April 19, 2021

RE: **Lot 2, Blk 1 Cliffs Unit 22 SAD 228**
8005 Alto Rey Ct. NW
Grading and Drainage Plan
Engineers Stamp Date 10/29/2020 (D10D003N2)
Pad Certification Date: 3/11/2021

TITLE: **GRADING AND DRAINAGE PLAN**

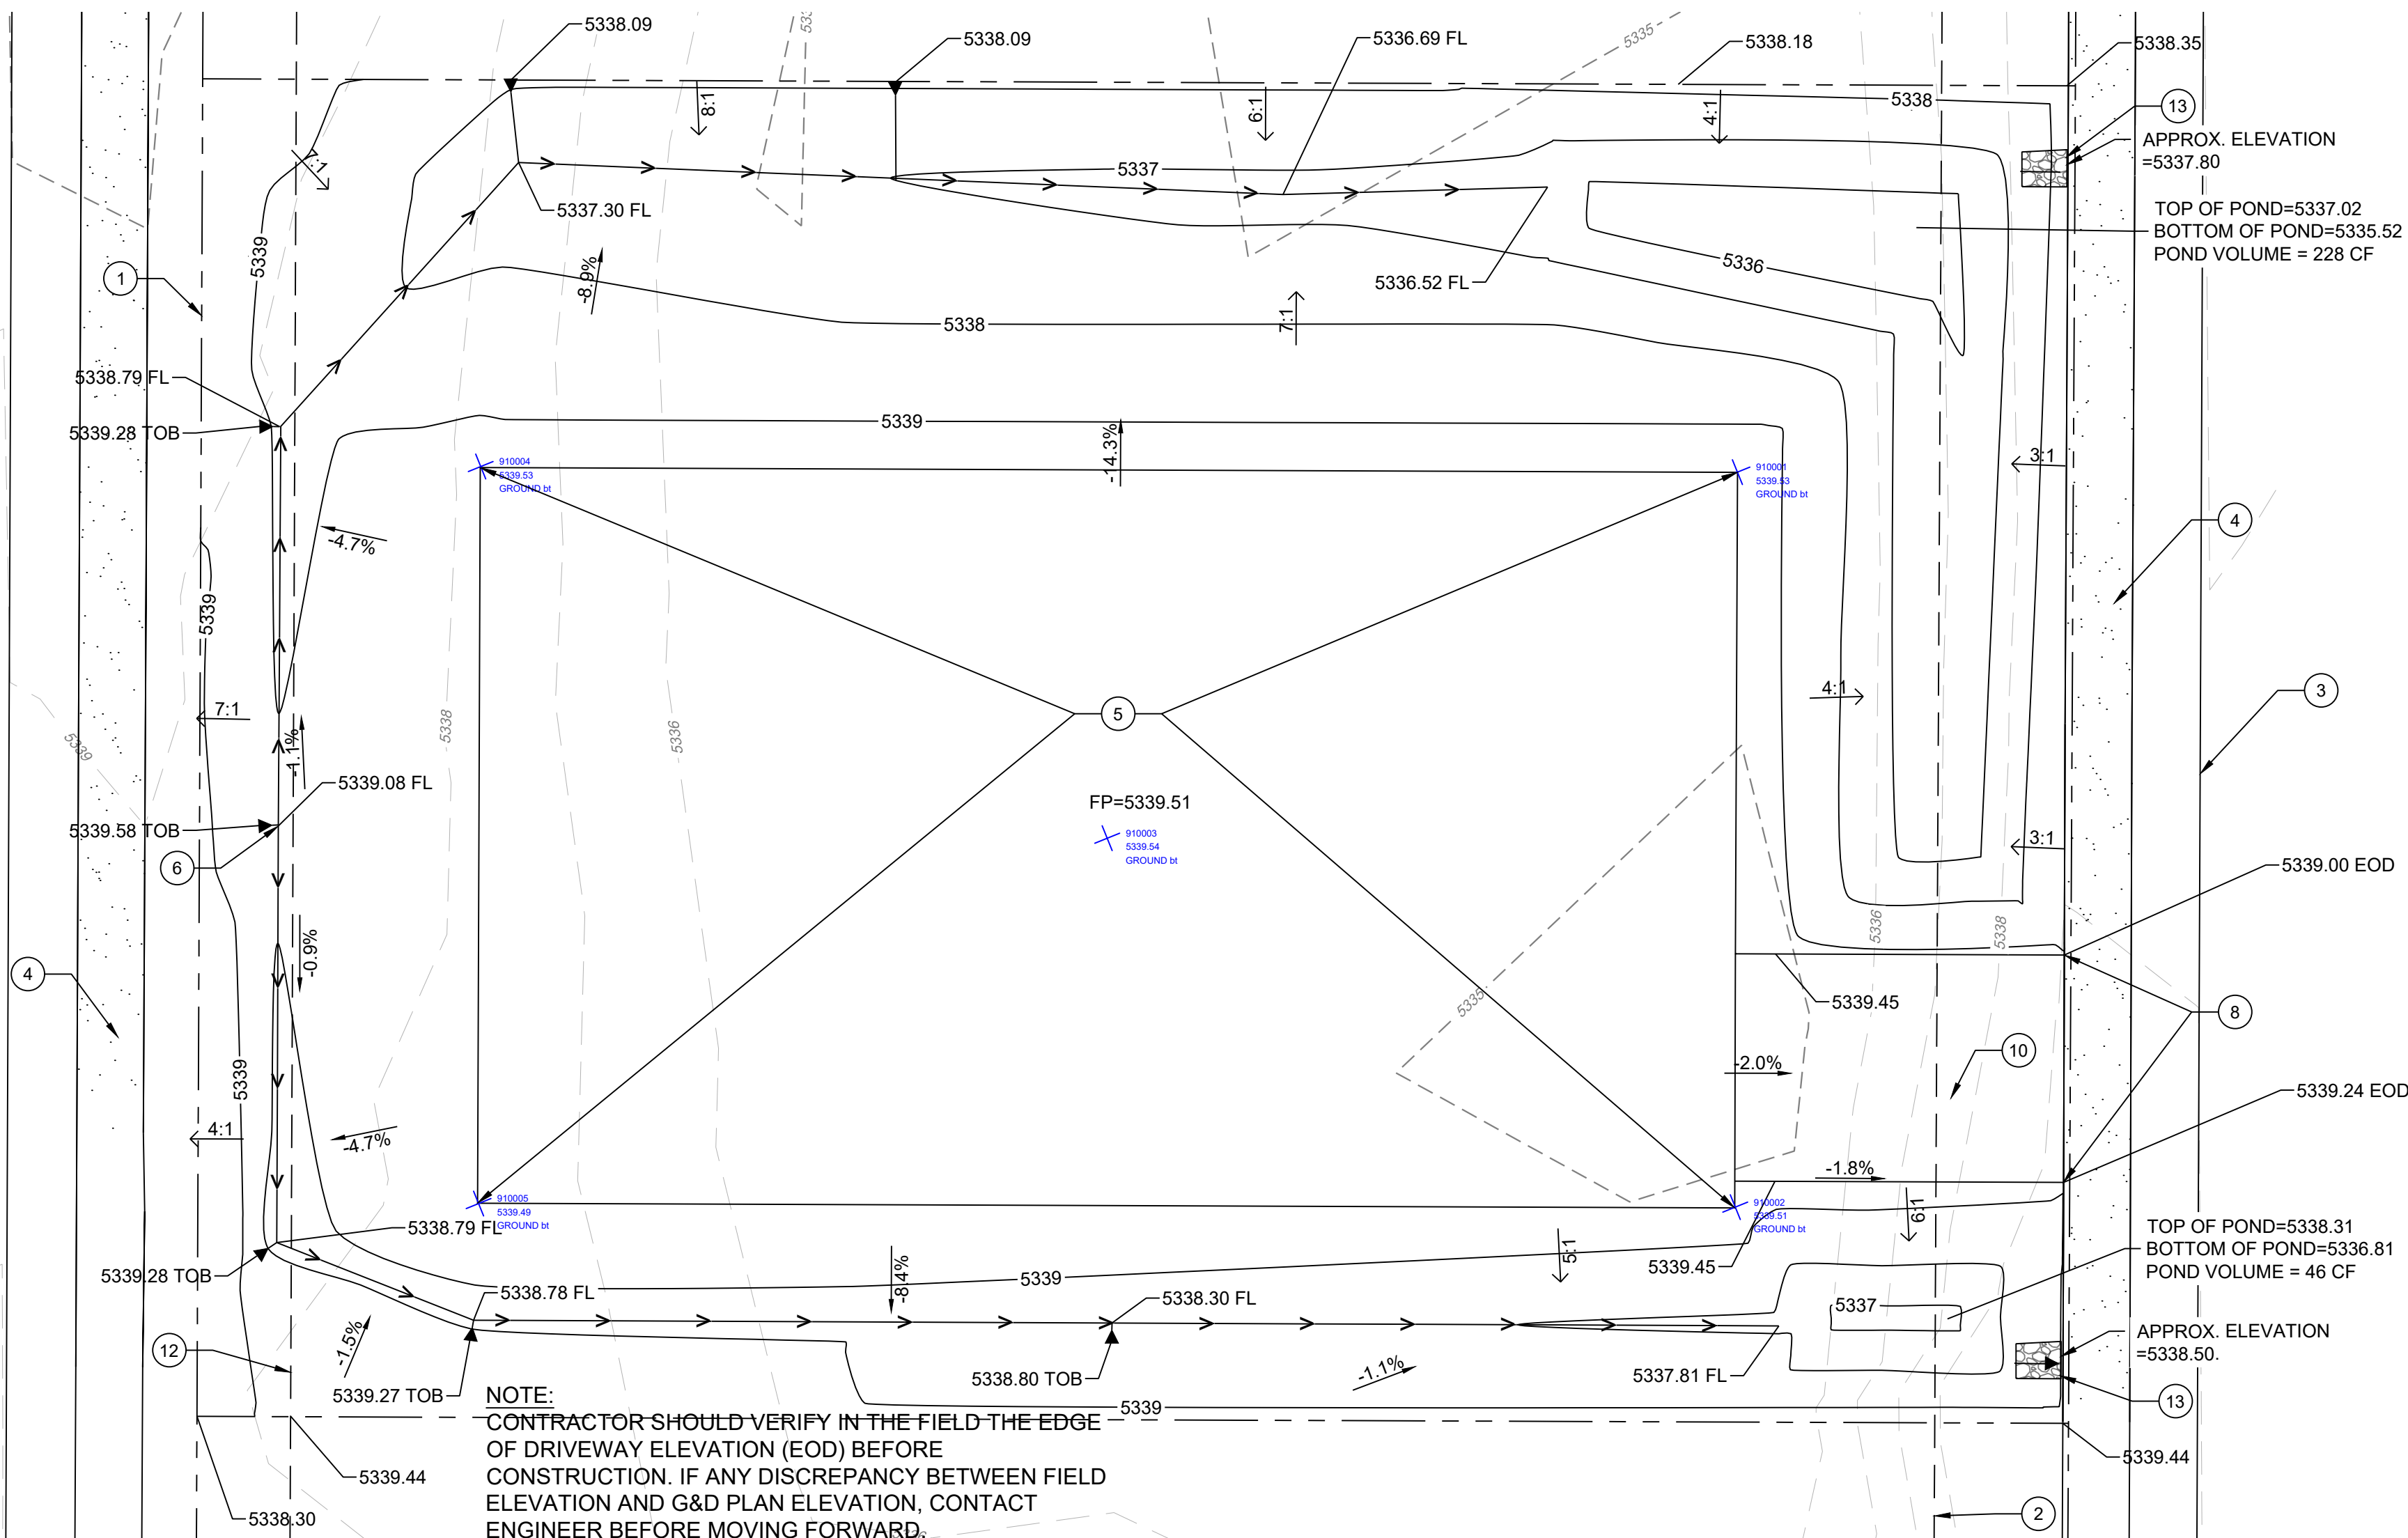
Based upon the information provided in your submittal received 4/19/2021, this plan is approved for Building Permit.

Prior to Building permit approval a Pad Certification will be required, provided by the Engineer or a registered Land Surveyor.

Reiterate to the Owner/Contractor that a separate permit for a garden/retaining wall must be obtained with the approved G&D plan and Pad Certification. **Also, if a swimming pool is to be placed the grading and drainage plan will change and will need to be resubmitted.**

Prior to Certificate of Occupancy release, Engineer Certification per the DPM checklist will be required.
